CONSTRUCTION SUMMARY

Lindsay 2017 Developments Inc. / Sugarwood

Lot/Unit: 12 Phase/Building: 2 Model/Floor Plan: Lovesick Lake (3705) Elev A 4Bed 2.5Bath

. 'DocuSign Envelope iD: 1968285E-53C3-403C-8404-959EA831C979
SCHEDULE "B-1"
Floor Plan

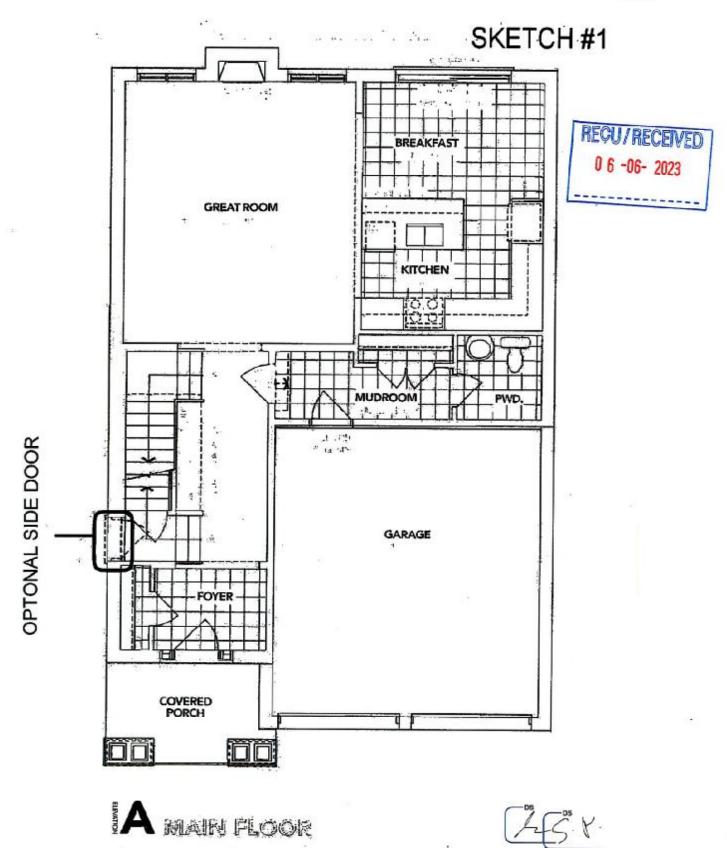
Line 79138	1 - TO SUPPLY AND INSTALL THE OPTIONAL SIDE DOOR SEE SKETCH #1 Note:	
Line 73136	Note.	
31May23 / 2Jun23		
PLUMBING	r F	
Inv.6272	1. TO SUPPLY AND INSTALL THE OPTIONAL 3-PC ROUGH-IN SEE SKETCH #2

SKETCH #2 RECU/RECEIVED 0 6 -06- 2023 PC ROCK RECU/RECEIVED O 6 -06- 2023

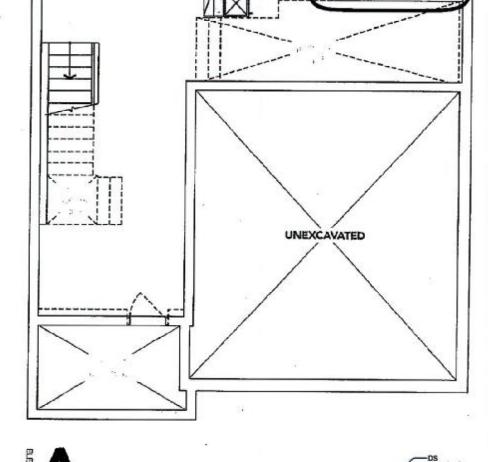
Inv. 6272	1 - TO SUPPLY AND INSTALL THE OPTIONAL 3-PC ROUGH-IN SEE SKETCH #2	
Line 79139	Note:	
31May23 / 2Jun23
